**REVISION 003 TO AN  
INVITATION TO TENDER**

<b>Title - Sujet :</b> Bank Re-vegetation Rocky Mountain House National Historic Site	
<b>Solicitation No. - N° de l'invitation :</b> 5P421-19-0008/A	<b>Date :</b> May 16, 2019
<b>Amendment No. - N° de modification :</b> 003	
<b>Client Reference No. - N° de référence du client :</b> N/A	
<b>GETS Reference No.   N° de référence de SEAG :</b> PW-19-00872382

## **Amendment 003**

This amendment is raised to answer questions from Potential bidders and distribute questions and answers from the optional site visit held on May 9, 2019.

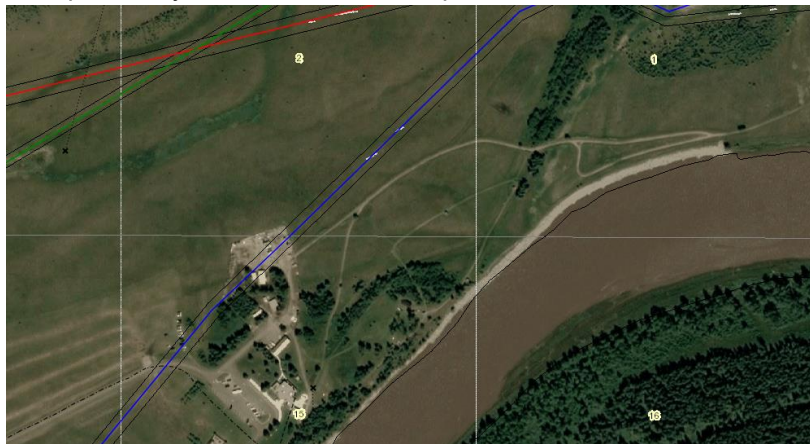
- Q12.** Are there any existing underground utilities on the site?
- A12.** According to the AbaData database (image below), there do not appear to be any registered utilities within the work area. Ground disturbance within the top of bank and staging areas is not permitted. Within the bank slope, <30cm of ground disturbance will be required. It is the contractor's responsibility to locate utilities if required.
